STAFF HEARING OFFICER STAFF REPORT

REPORT DATE: March 26, 2015
AGENDA DATE: April 1, 2015
PROJECT ADDRESS: 1516 Castillo Street (MST2014-00319)
TO: Susan Reardon, Senior Planner, Staff Hearing Officer
FROM: Planning Division, (805) 564-5470
 Danny Kato, Senior Planner *DK*
 Jo Anne La Conte, Assistant Planner *JAL*

CONCEPT REVIEW - NEW ITEM: PUBLIC HEARING**1. 1516 CASTILLO ST****R-4 Zone****(3:15)**

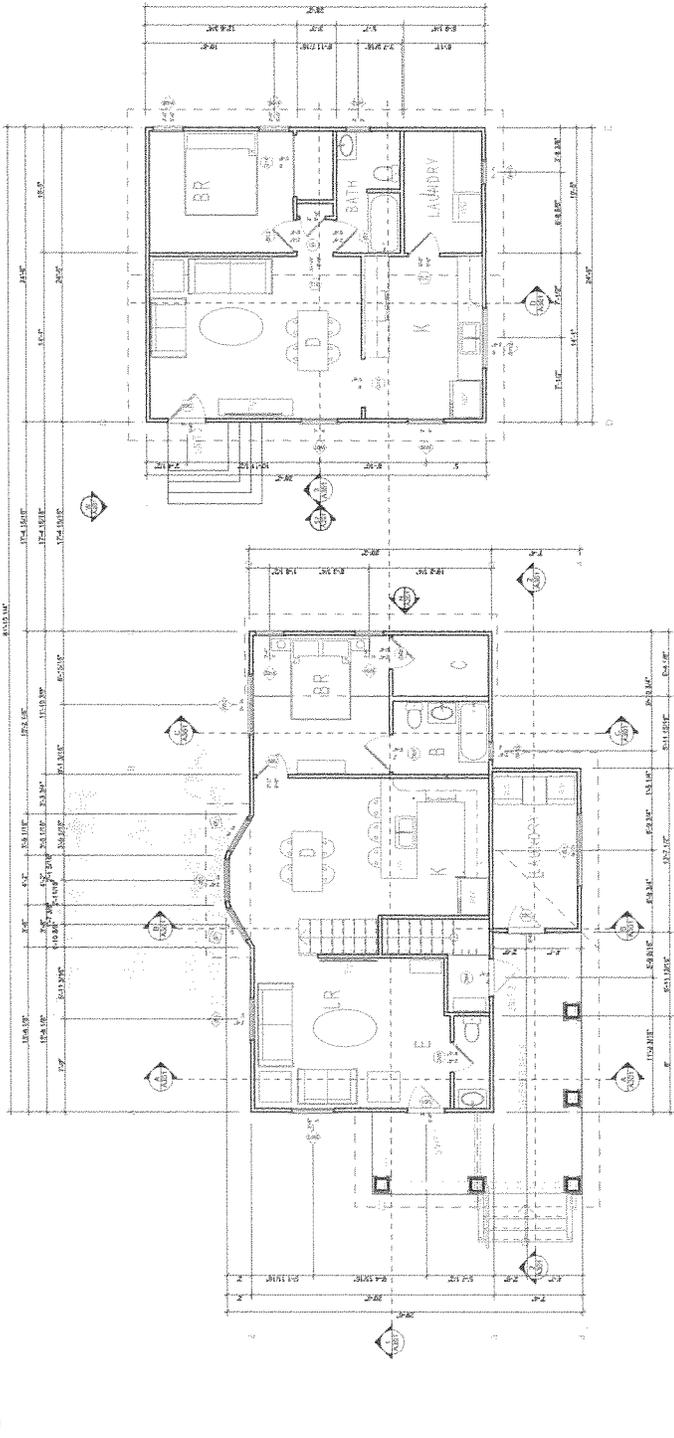
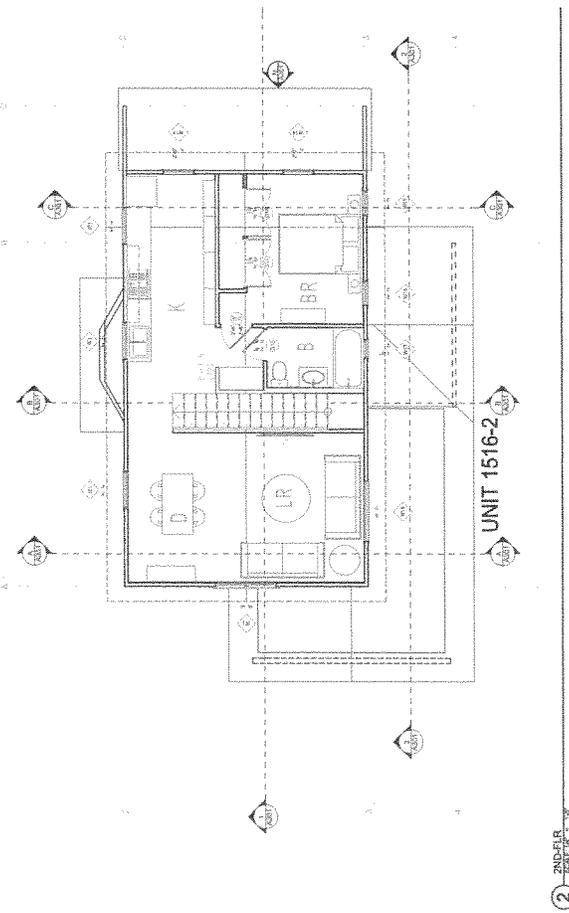
- 1) The Board finds the proposed parking modification request for three uncovered parking stalls to be aesthetically appropriate, and does not pose consistency issues with Architectural Board of Review Design Guidelines.
- 2) Provide adequate landscaping around the three uncovered parking stalls; preferably taller screening landscaping.
- 3) Provide a landscape plan with an outdoor lighting fixture plan and details.
- 4) Provide vine pockets along the fence.
- 5) Show Storm Water Management Program (SWMP) compliance.
- 6) Provide a street tree at the front of the property, as well as landscape plans. Enhance the ground plane at the parkway area with paving or landscape material.
- 7) Add permeable paving for the driveway.
- 8) Provide additional window details on the front structure; study to provide a consistent window style to replace the original double-hung style.
